**Clackamas County Planning and Zoning Division
Department of Transportation and Development**

NOTICE OF LAND USE APPLICATION IN YOUR AREA

SELF STORAGE FACILITY - Design review of alterations to existing warehouse and development of new three-story building, to be used as a self storage facility. Project will include new site access, circulation, landscaping, and right of way improvements.

Permit Number: Z0229-19

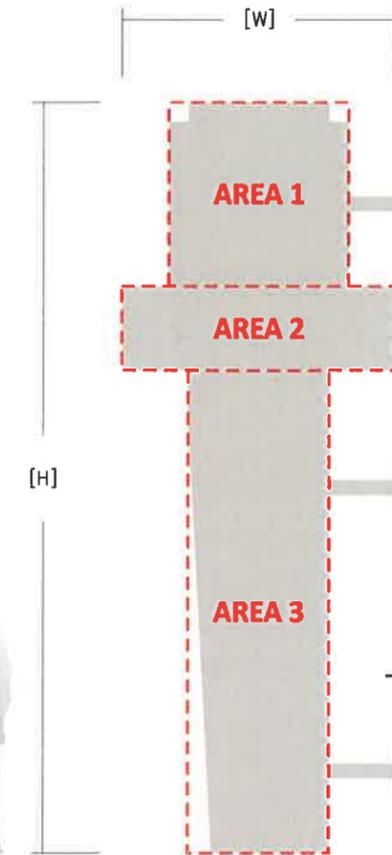
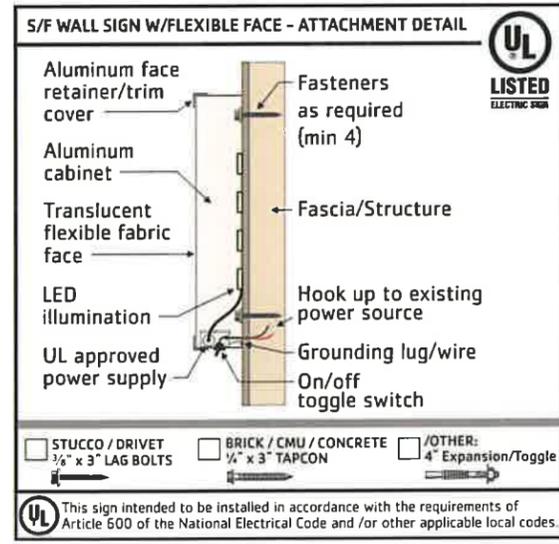
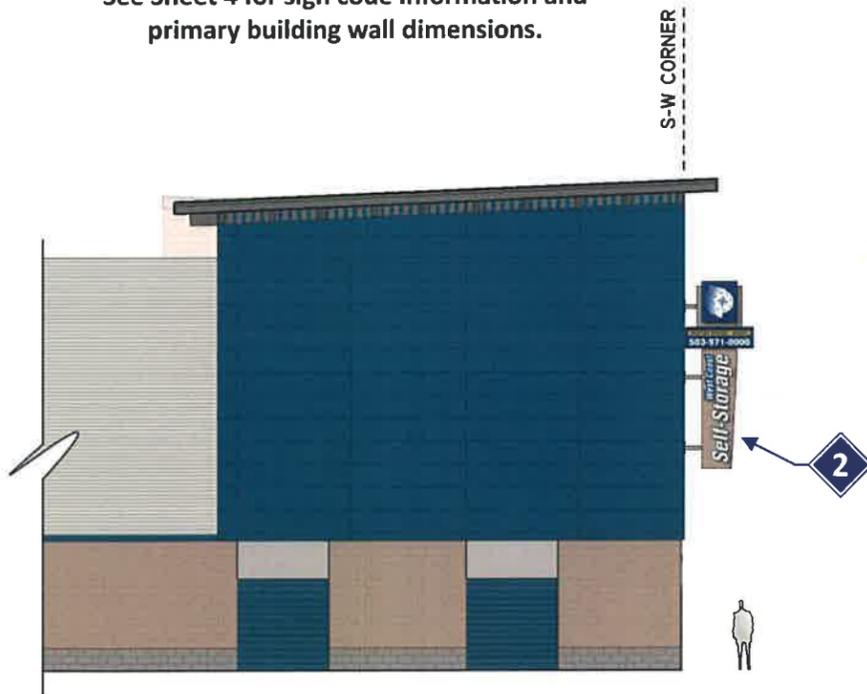
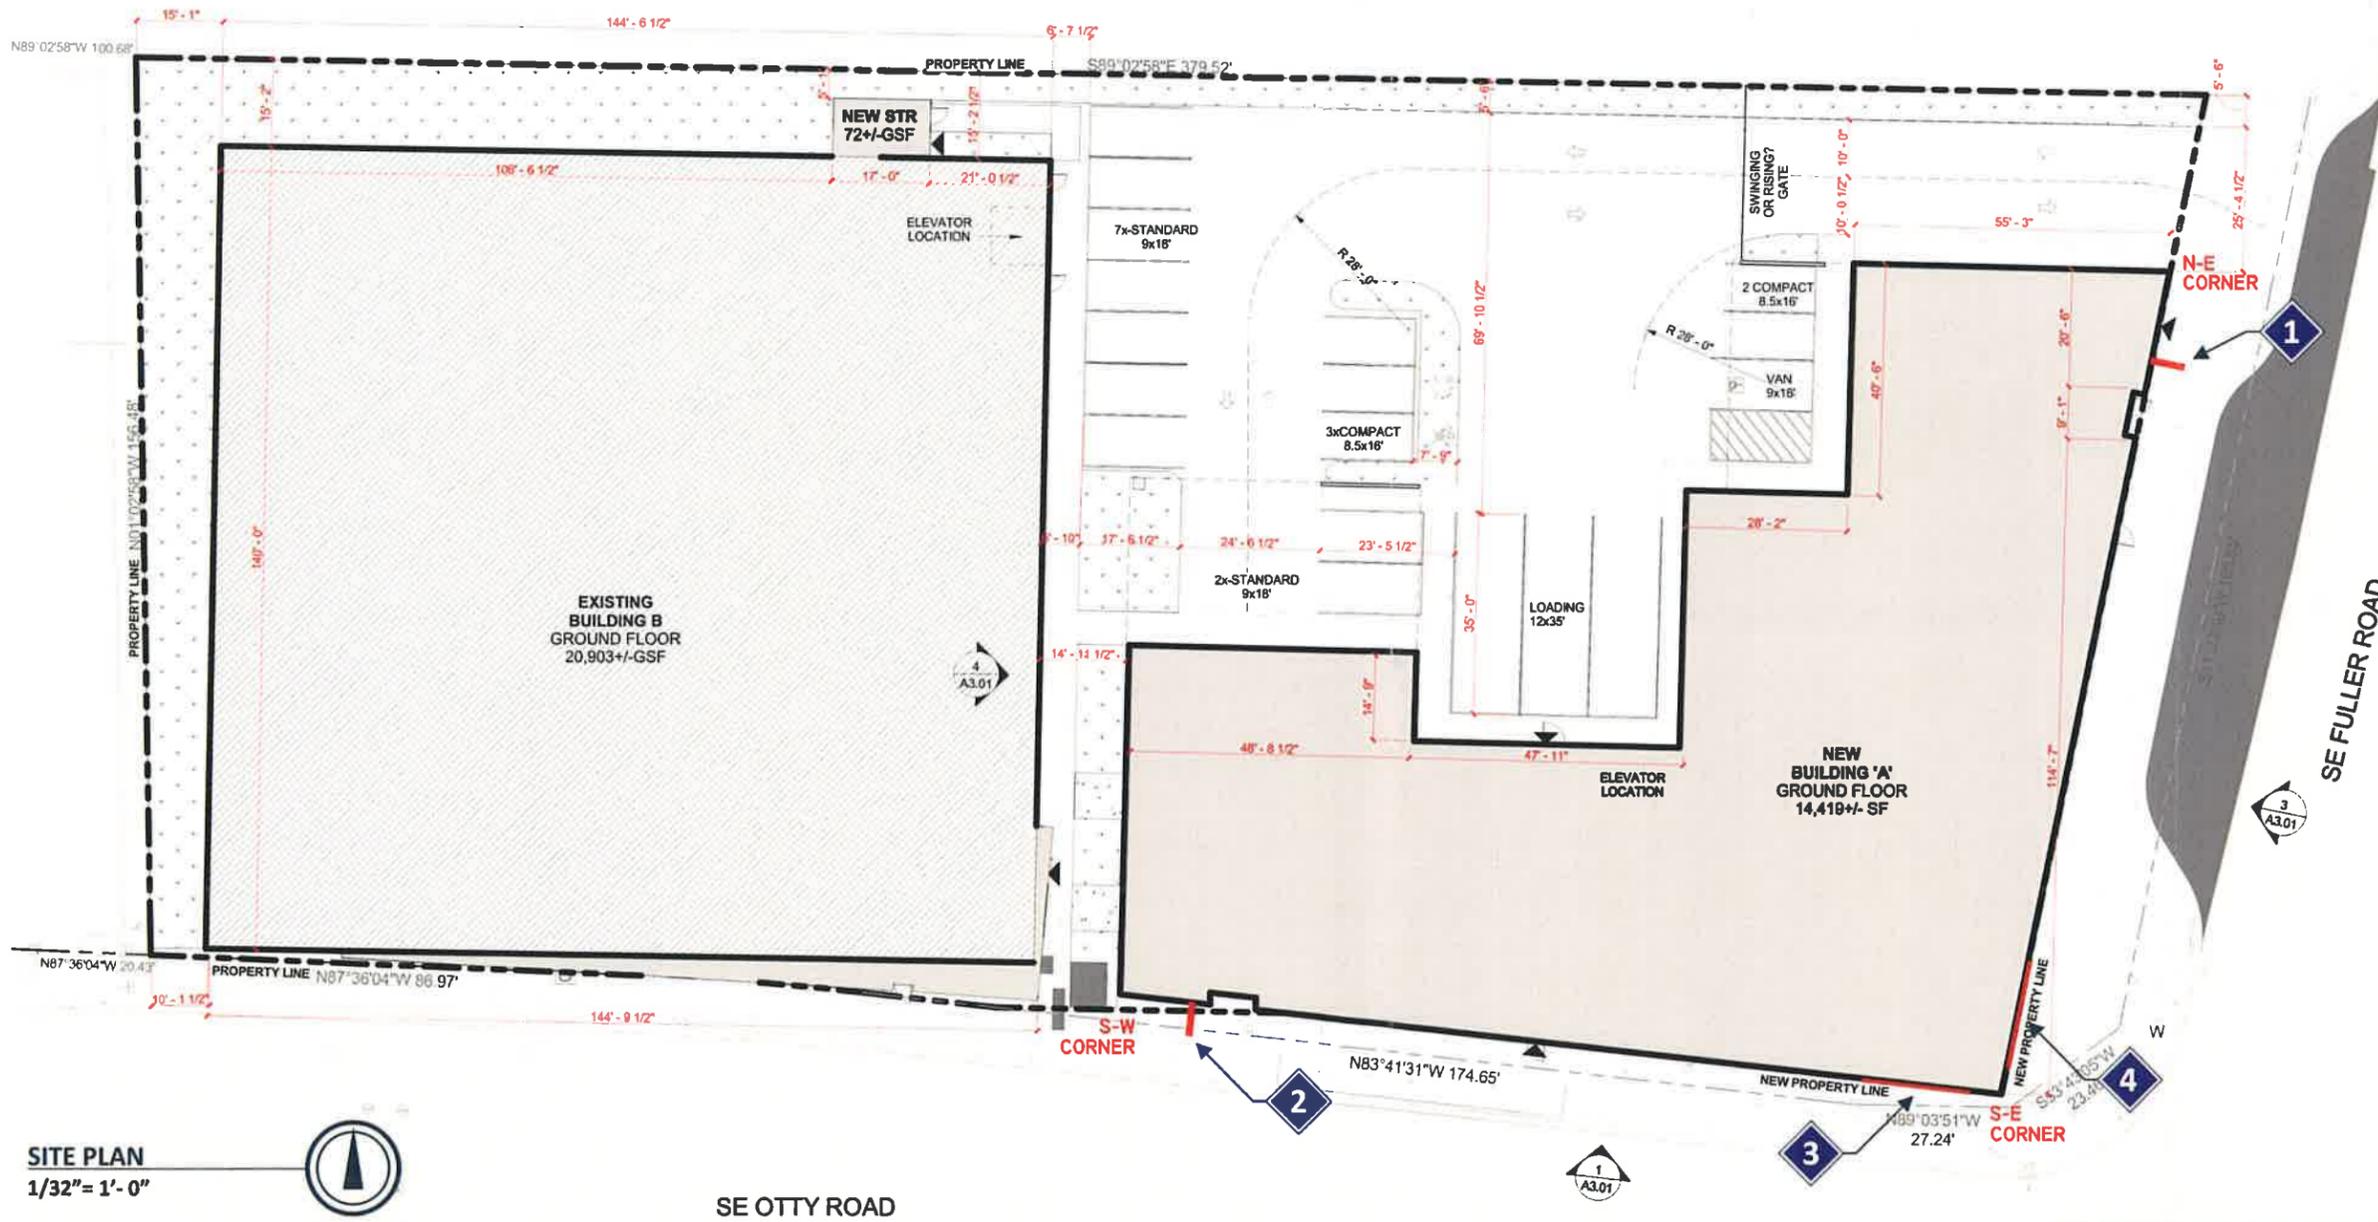
1010: Signs are indicated in the submitted drawings. If the signs are to be considered and approved through this Design Review application, please provide additional information and dimensional information so that they may be evaluated relative to the standards of ZDO 1010.

- SEE SHEET 3 FOR BUILDING ELEVATION DRAWINGS WITH SIGN LOCATIONS
 - SEE SHEET 4 FOR SITE PLAN WITH SIGN LOCATIONS

Sign package area based on Building 'A' and Building 'B' primary building wall linear footage.
